SUBJECT: Application for amend to License NPF-63, revising Tech Specs
 to allow for efficient fuel designs & provide max
 operational flexibility for routine & nonroutine plant
 operations in support of Cycle 2 operation. Fee paid.

SHEARON HARRIS NUCLEAR POWER PLANT
DOCKET NO. 50-400/LICENSE NO. NPF-63
REQUEST FOR LICENSE AMENDMENT
CYCLE 2 OPERATION

BASIS FOR CHANGE REQUEST
D-BANK RECONFIGURATION - CONTROL ROD INSERTION LIMITS

FIGURE 3.1-1
ROD GROUP INSERTION LIMITS VERSUS THERMAL POWER THREE-LOOP OPERATION

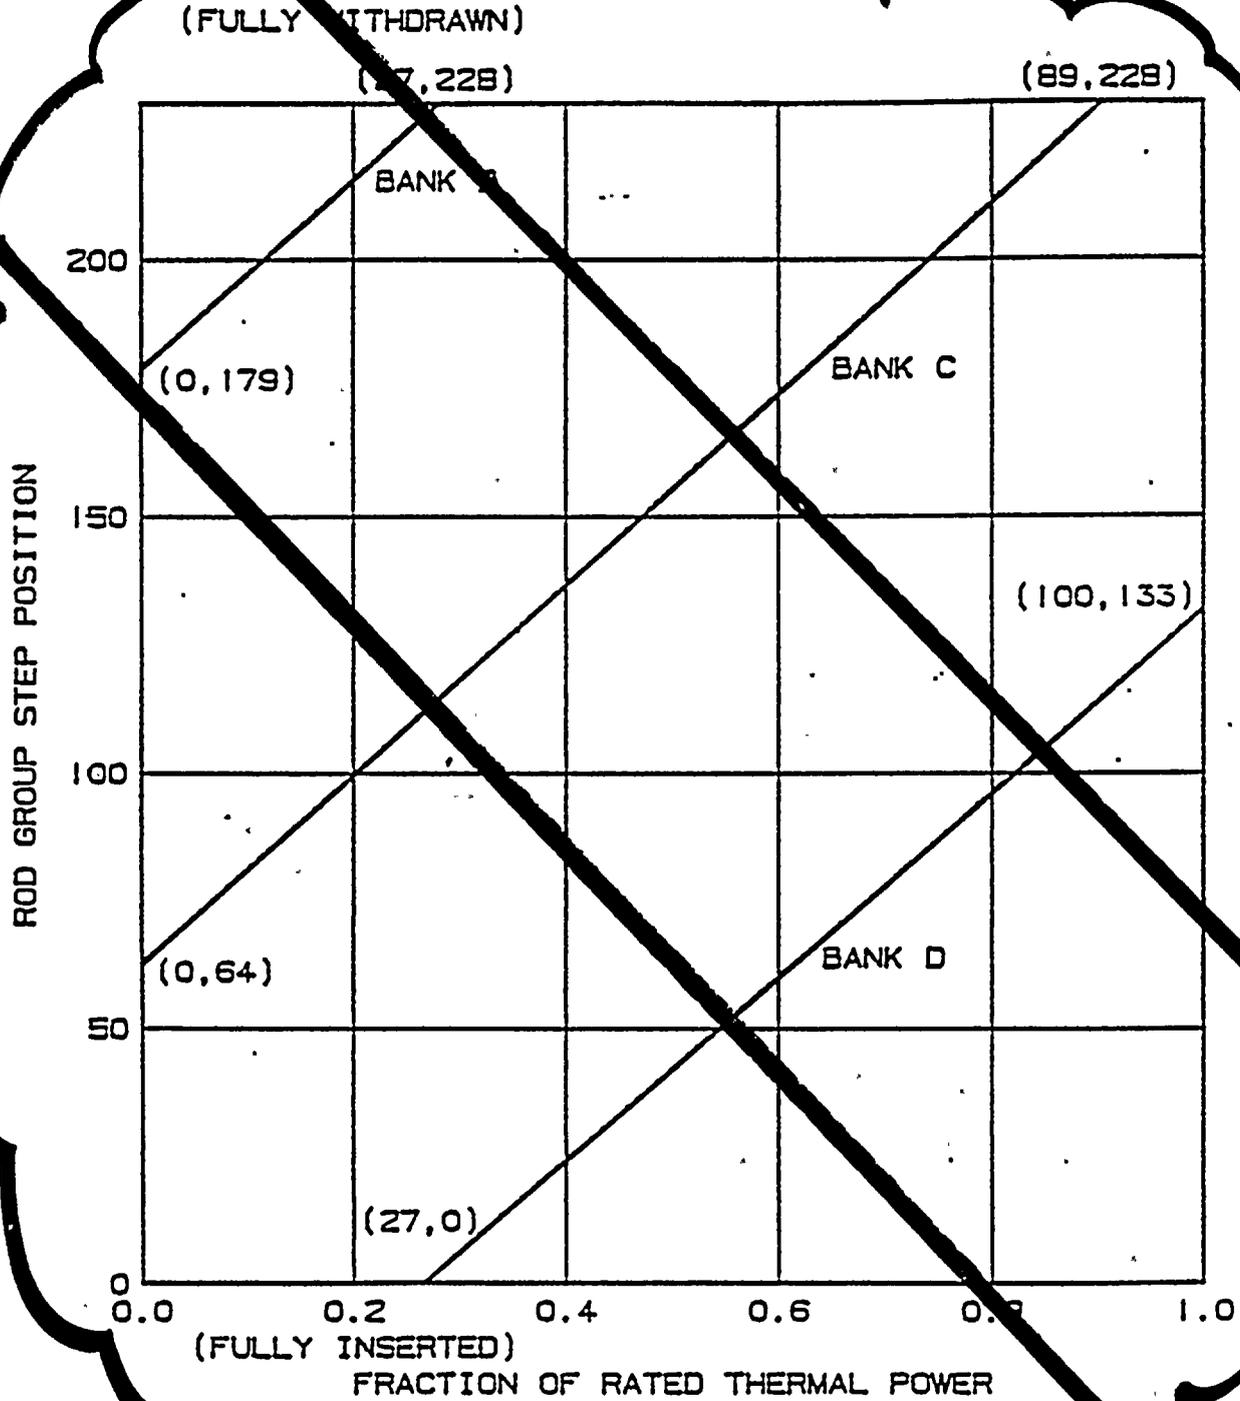
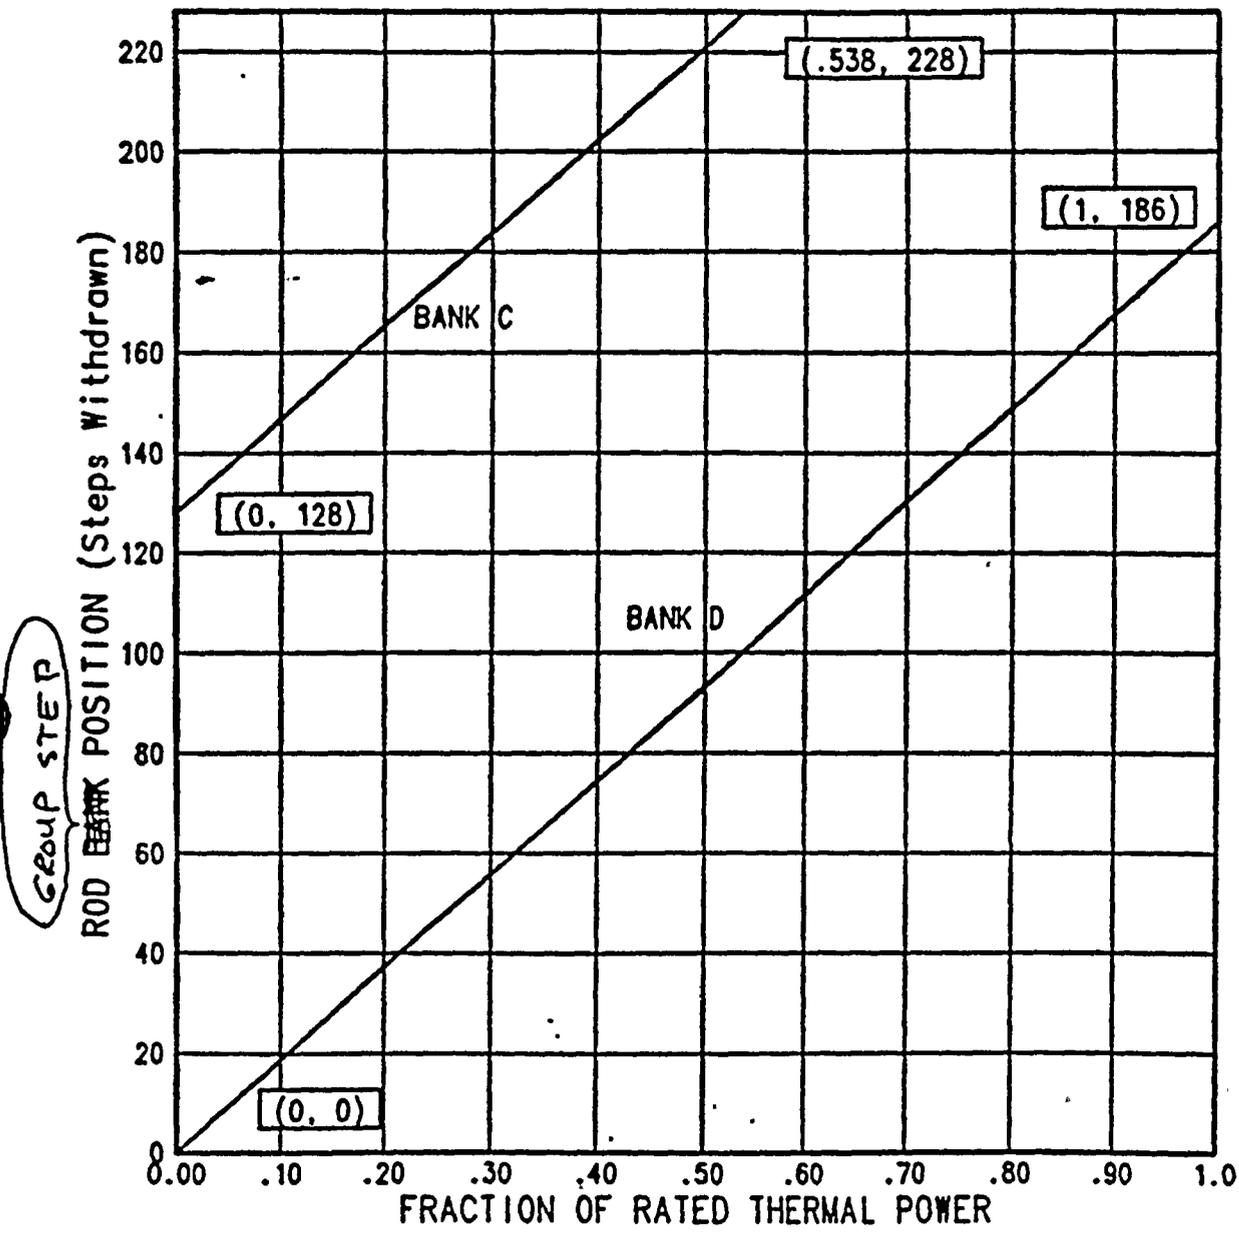
The proposed amendment revises Technical Specification Figure 3.1-1, Rod Group Insertion Limits Versus Thermal Power Three-Loop Operation as shown on the enclosed revised Technical Specification pages.

The addition of rods to Control Bank D increases the reactivity worth of the control bank. Consequently, a revision in the rod group insertion limits shown on Technical Specification Figure 3.1-1 is necessary. The rod insertion limits ensure that acceptable power distribution limits are maintained, minimum shutdown margin is maintained, and the potential effects of rod misalignment on associated accident analyses are limited.

1. The proposed amendment does not involve a significant increase in the probability or consequences of an accident previously evaluated. The revised rod insertion limits provided in Technical Specification Figure 3.1-1 were established to ensure that: (1) acceptable power distributions are maintained during normal operation; (2) shutdown margin is maintained; and (3) the accident analyses conclusions provided in the SHNPP FSAR remain valid. As such, the consequences of previously evaluated accidents are not significantly increased by the proposed amendment.

FIGURE 1
 AXIAL FLUX DIFFERENCE LIMITS AS A FUNCTION OF
 RATED THERMAL POWER FOR RAOC

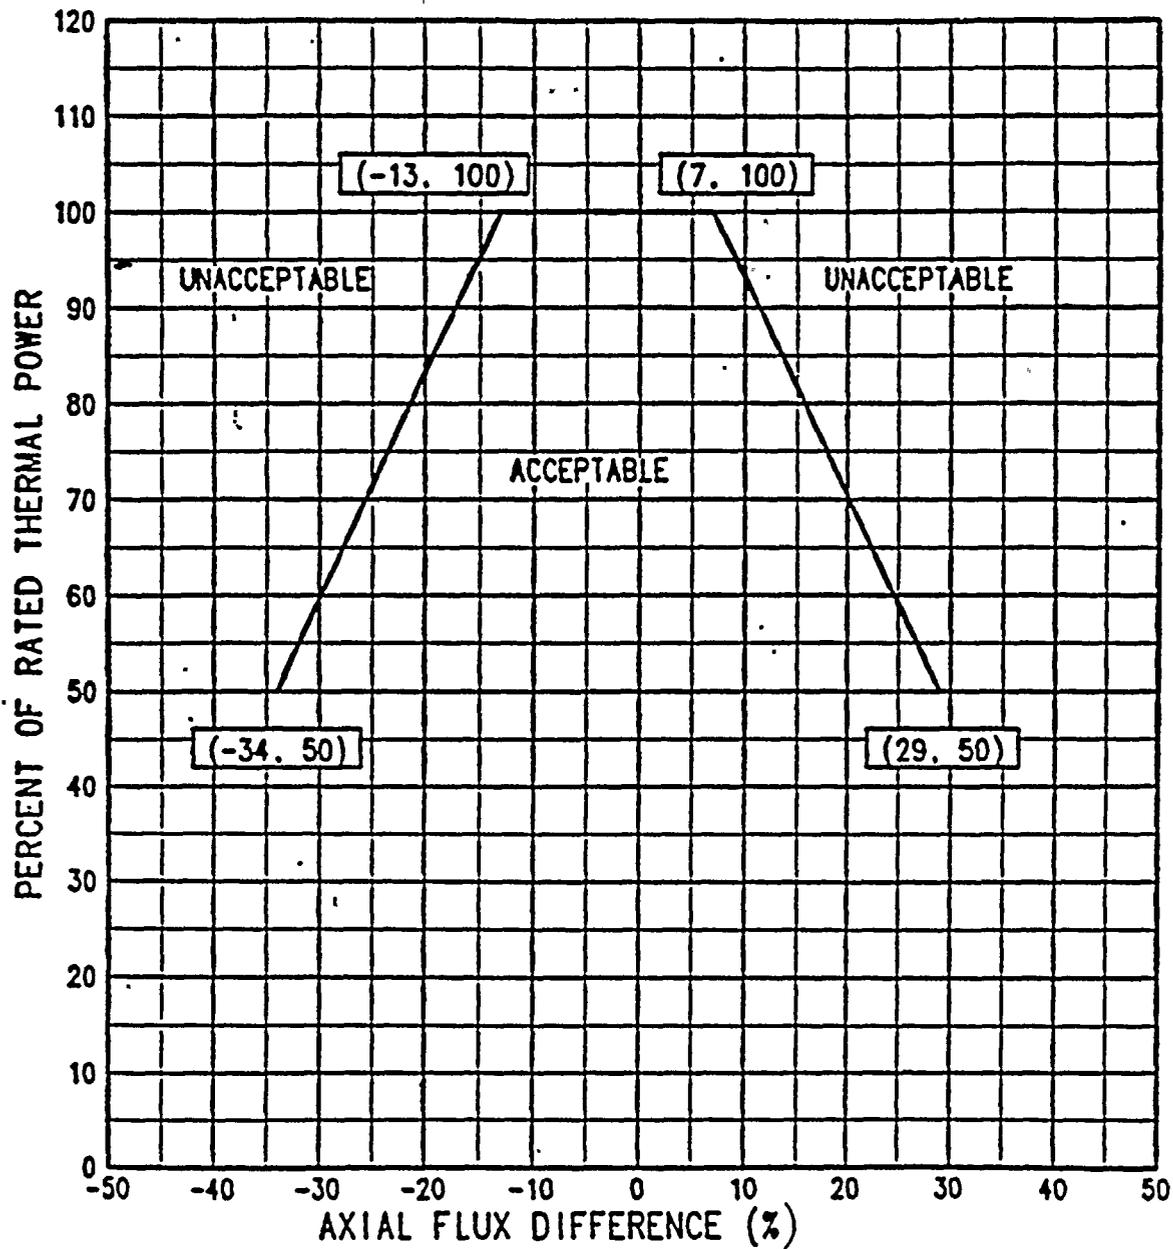
The methodology used to generate the AFD limits for RAOC operation is described in detail in Reference 2. Briefly, axial power distributions generated from the one-dimensional code were synthesized with three-dimensional radial power distributions to generate the total peaking factor $F_Q^T(z)$. Using this methodology, the allowable AFD limits for RAOC operation were determined and are presented in Figure 1.
